CNL-19-007

Browns Ferry Nuclear Plant, Units 1, 2, and 3
Renewed Facility Operating License Nos. DPR-33, DPR-52, and DPR-68
NRC Docket Nos. 50-259, 50-260, and 50-296

Subject: Proposed Technical Specifications (TS) Change TS-510 - Request for License Amendments - Maximum Extended Load Line Limit Analysis Plus - Supplement 5, Response to Requests for Additional Information

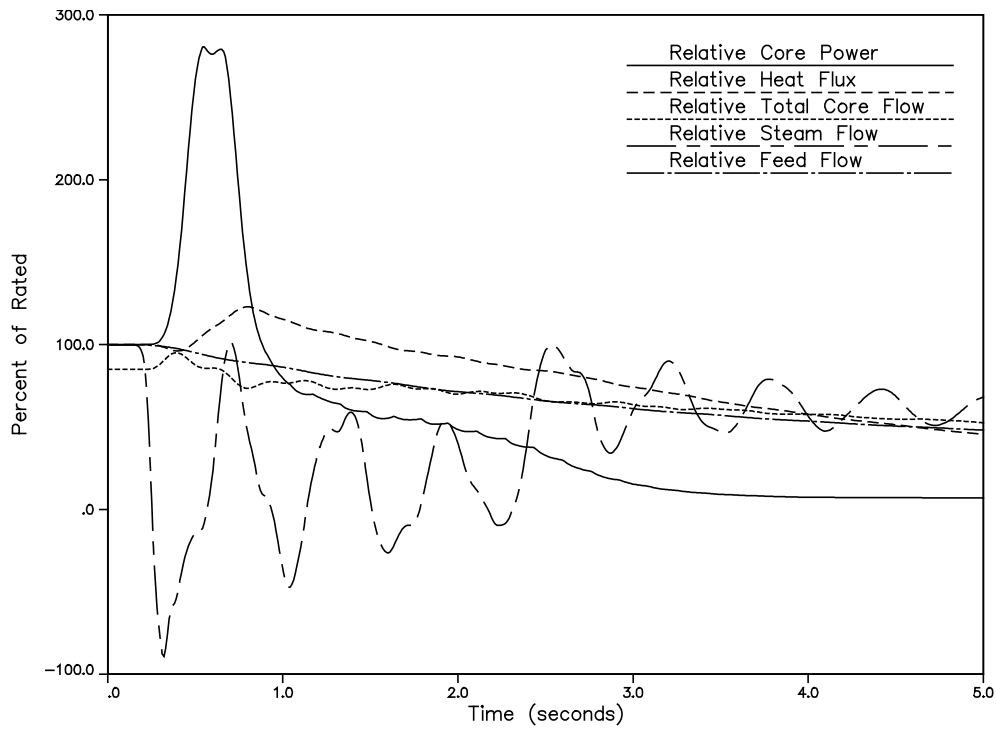
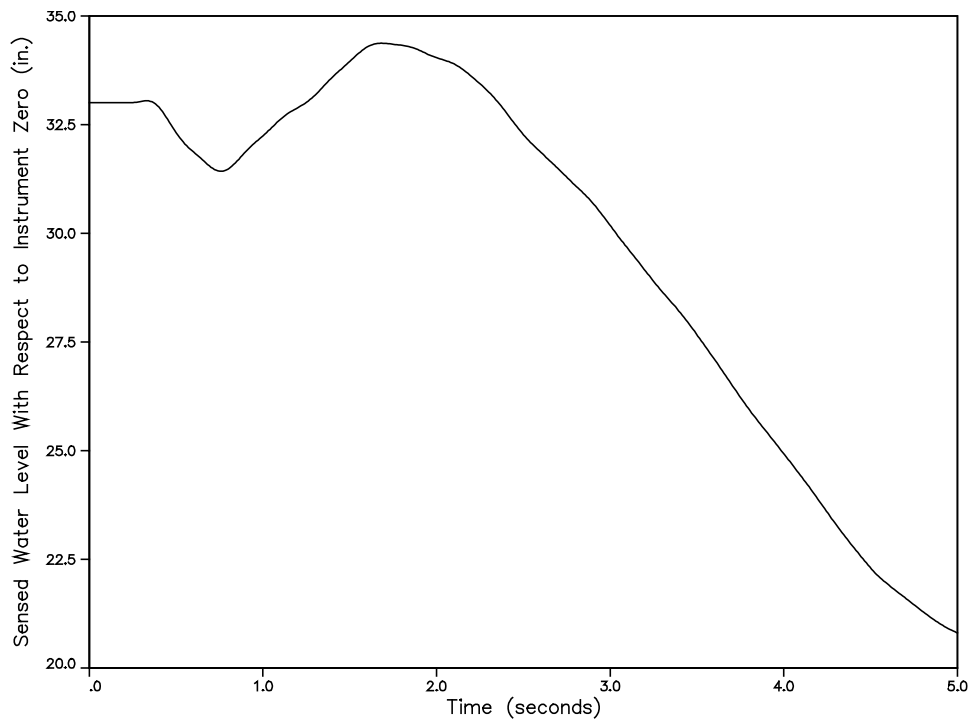
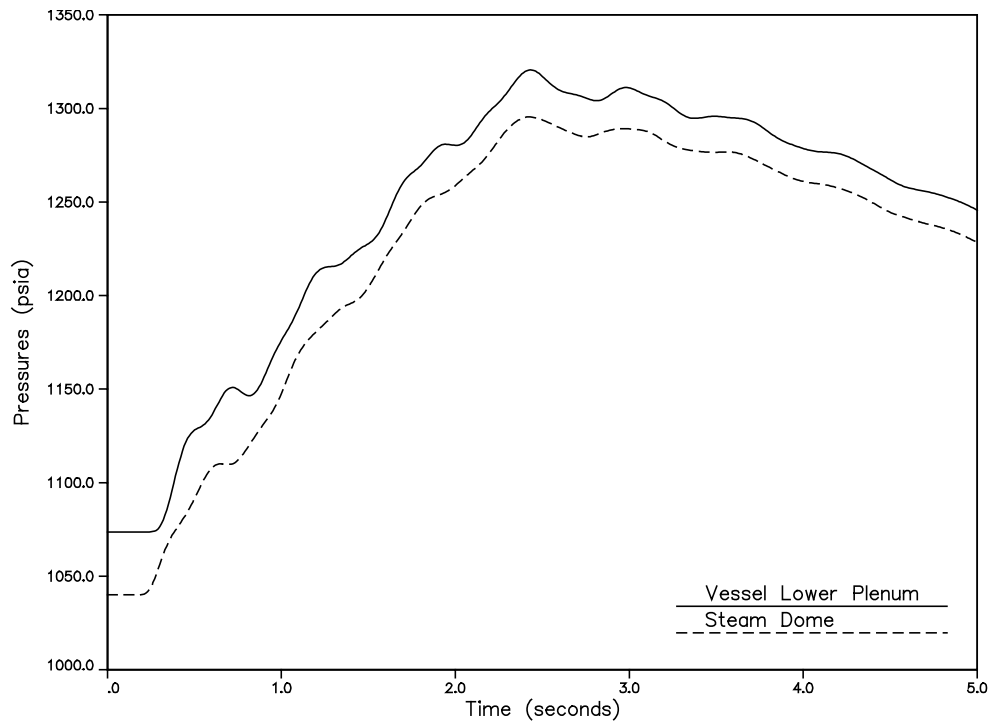
Provide the key parameter figures (like those in ANP-3552 Figures 5.1 through 5.6) for the 100 percent power and 85 percent core flow case for load reject no-bypass and the feedwater controller failure to understand the impact of MELLLA+ on these analyses to ensure they meet draft GDC 7. Discuss if the AOOs are reanalyzed each reload for all the MELLLA+ domain statepoints, and if not, describe why reanalysis is not necessary and what parameters are checked to ensure the original cases remain bounding (i.e., describe why the bounding analyses first analyzed for MELLLA+ will remain bounding in future cycles).*

Plots for the load reject no-bypass (LRNB) event and the feedwater controller failure (FWCF) at 100% rated core power, 85% rated core flow are shown in Figures 1 – 3 and Figures 4 – 6, respectively.

Additionally, the potentially limiting transient events analyzed on a cycle-specific basis (LRNB and FWCF events) must protect the entire power/flow map. Consistent with the Unit 1 transition, ATRIUM 10XM fuel transition, and the EPU LAR, the EPU/MELLLA+ LAR performed a full scope of transient analyses where the highest and lowest allowed core flow was evaluated for a given core power. In each of these instances, it was determined that high core flow provided the bounding result.

Figure SRXB RAI-5b-1

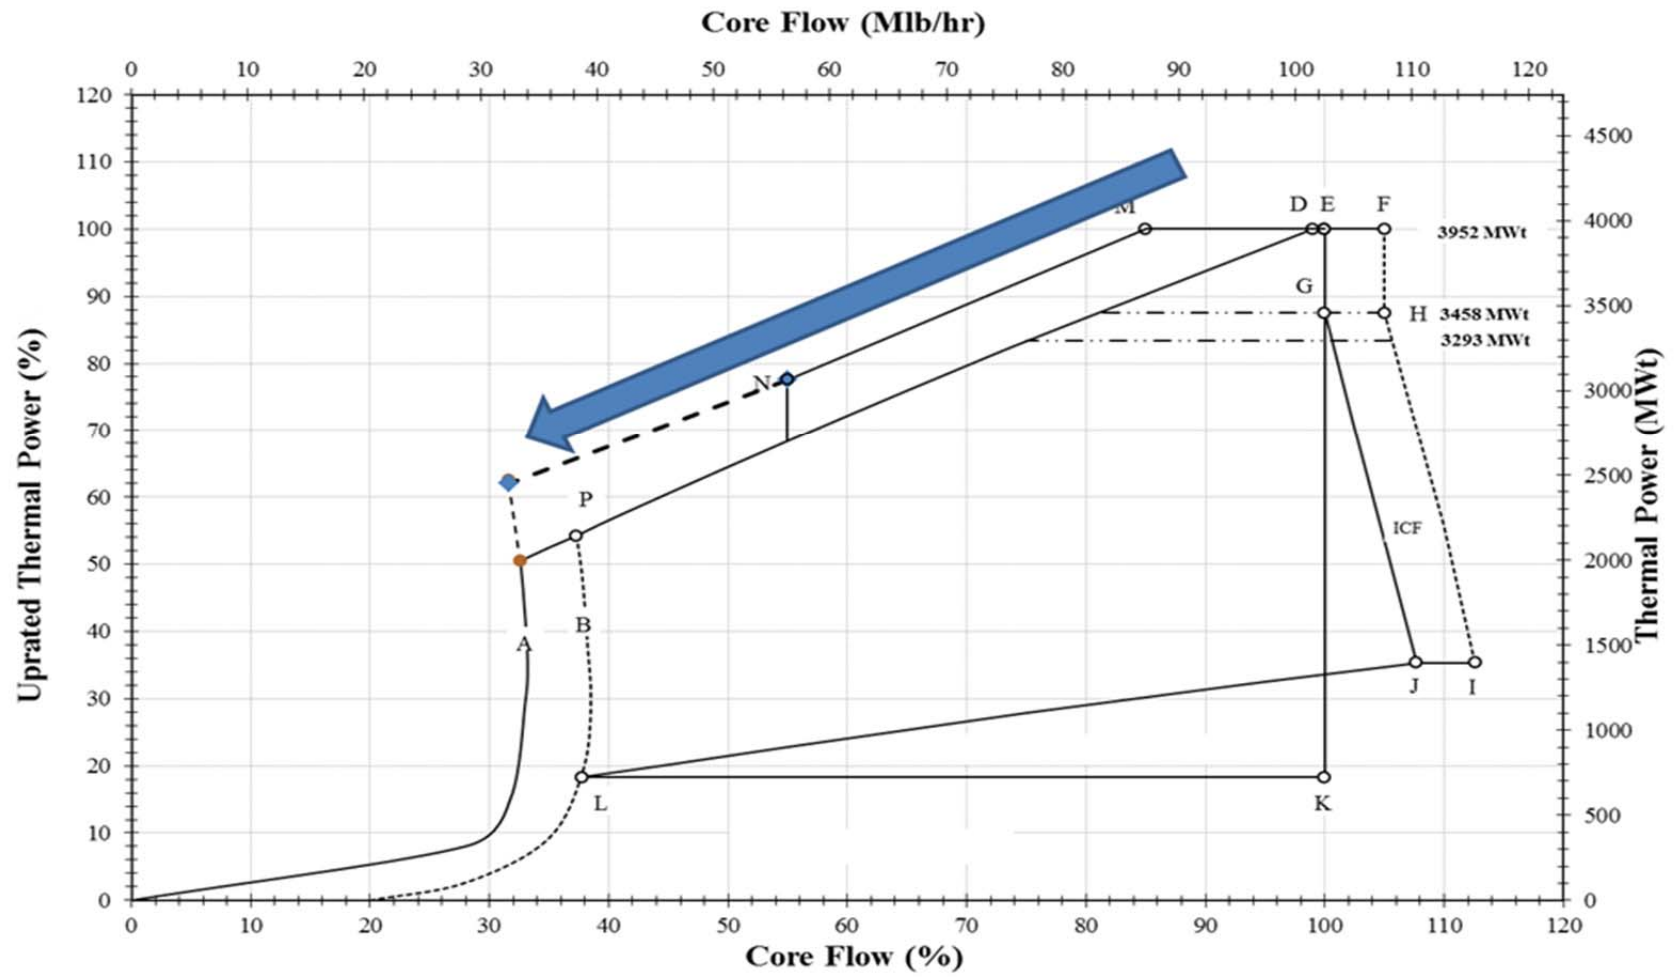
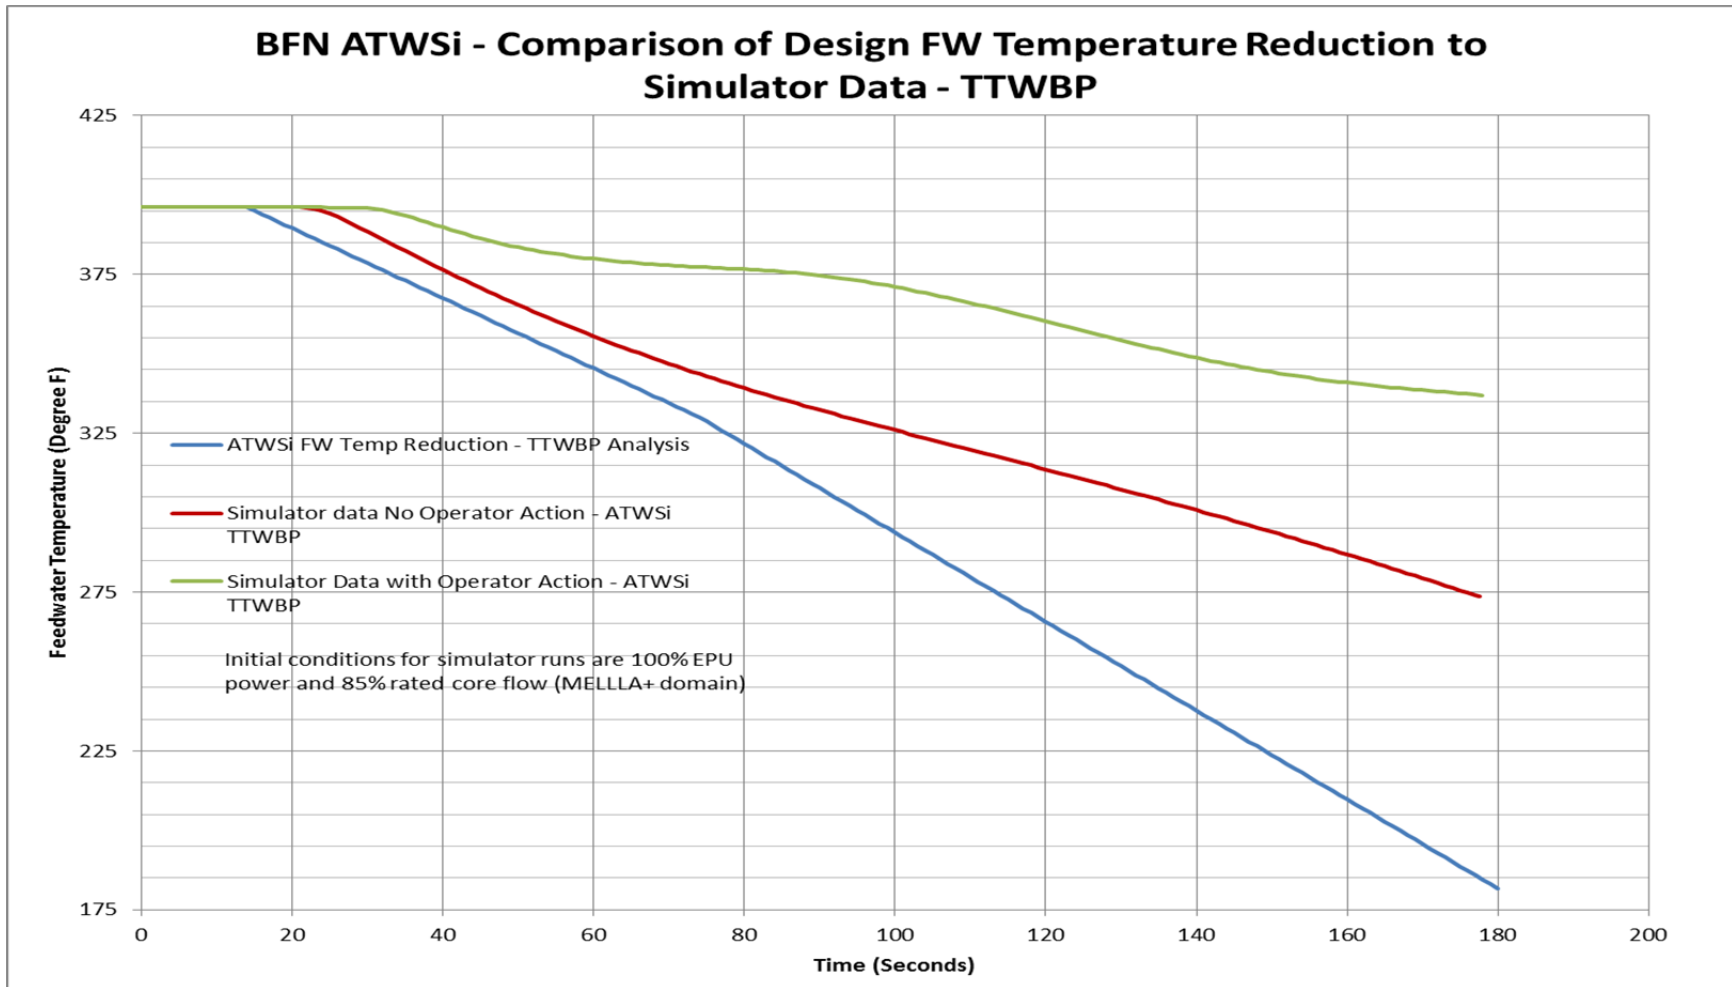
- a. Provide the basis for the 39,800 lbm used in the calculation which determined the 14 seconds delay time.*
- b. Justify that the 14 seconds delay time is bounding relative to the turbine trip event data for BFN, Unit 3.*
- c. Explain why the feedwater temperature reduction rate changes during the turbine trip event at BFN, Unit 3 (Step 1, Step 2, and Step 3) and please discuss why this is bounding for ATWS-I.*
- d. Please compare the TRACG feedwater temperature input to ATWS simulator data to demonstrate that the feedwater temperature used in the analysis is conservative.*
- e. Please provide justification that this basis is also applicable to the feedwater temperature reduction for the 2RPT event.*

The above computation assumes an instantaneous reduction in core flow and a corresponding instantaneous reduction in FW flow from 100% of rated to 62% of rated upon trip of the recirculation pumps. In actual plant operation, the core flow reduction and the corresponding FW flow response is not instantaneous; core flow, power and FW flow reach steady-state conditions about 30 seconds after the recirculation pumps trip. During this 30 second time period, the average FW flow is approximately 73% of rated FW flow. Factoring the product of the BFN Unit 3 turbine trip delay time (60 seconds) and the BFN Unit 3 turbine trip FW flow (approximately 4 Mlbm/hr) by the average FW flow following the reactor recirculation pump trip (rated FW flow of 16.4 Mlbm/hr x 73%) results in a delay time of $((60\text{second} \cdot 4\text{Mlbm/hr}) / (16.4\text{Mlbm/hr} \cdot 73\%)) = 20$ seconds. Therefore, the 14 second delay time used in the TTWBP ATWS-I analysis is bounding relative to the delay time calculated from the BFN Unit 3 turbine trip data.
